# Preliminary Geotechnical Investigation

**1881/1883 Merivale and Adjacent Lot, Ottawa**

26 September 2023

## 7 City of Ottawa comment responses- Geotechnical Review of Drawings/ Plans-

Drawing Title: **GRADING, DRAINAGE AND EROSION & SEDIMENT CONTROL PLAN**

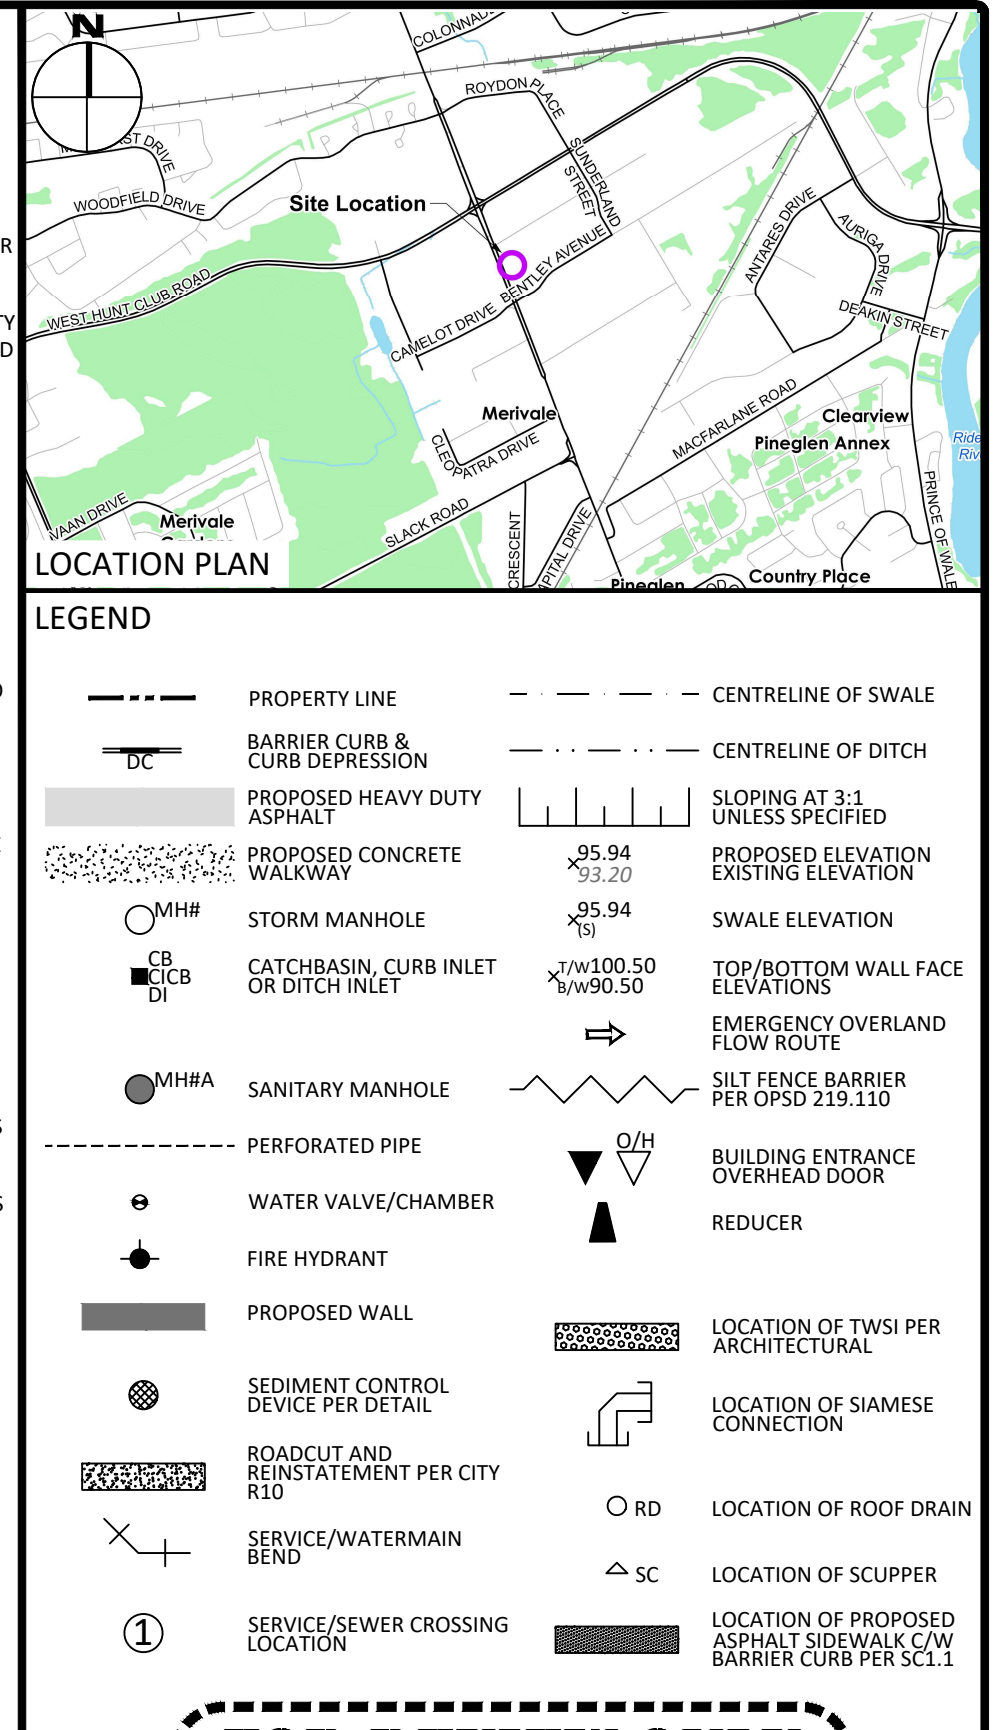
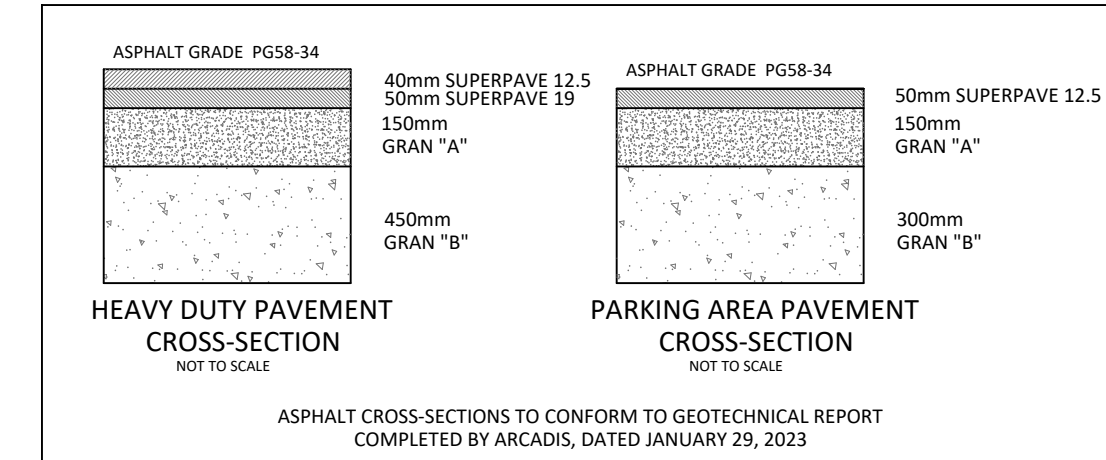
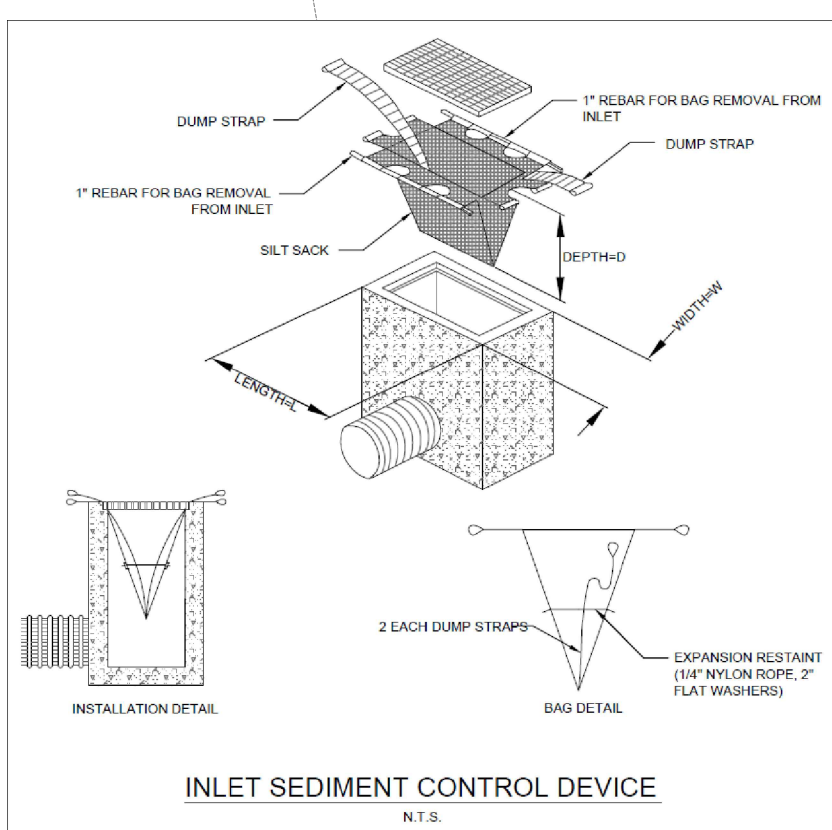
- The site plan prepared by McRobie/Arnon: Project No. 19-120, Drawing SP-A01, Site Plan, Revision 7 dated 16 May 2023; and
- The grading plan prepared by McIntosh-Perry: Project No. CCO-23-1150, Drawing C101, Grading, Drainage and Erosion & Sediment Control Plan, Revision 1, distributed 2023.05.24.
- Tree Report and Landscape Plan- JBLA, Drawing L-1; dated Feb. 7, 2023

There are currently no outstanding geotechnical concerns with respect to the drawings/plan presented and as listed above. All drawings provided appear to be in keeping with the geotechnical recommendations provided in this Geotechnical Investigation report, dated 4 August 2023.

No significant grade raise is anticipated in this development planning. Based on the absence of Clay soils, we do provide any recommendations to restrict potential minor changes or low raising of site grades. No current concerns with site grading were identified, following review of the drawing Grading, Drainage and Erosion & Sediment Control Plan (C101) by McIntosh Perry, distributed 2023.05.24.
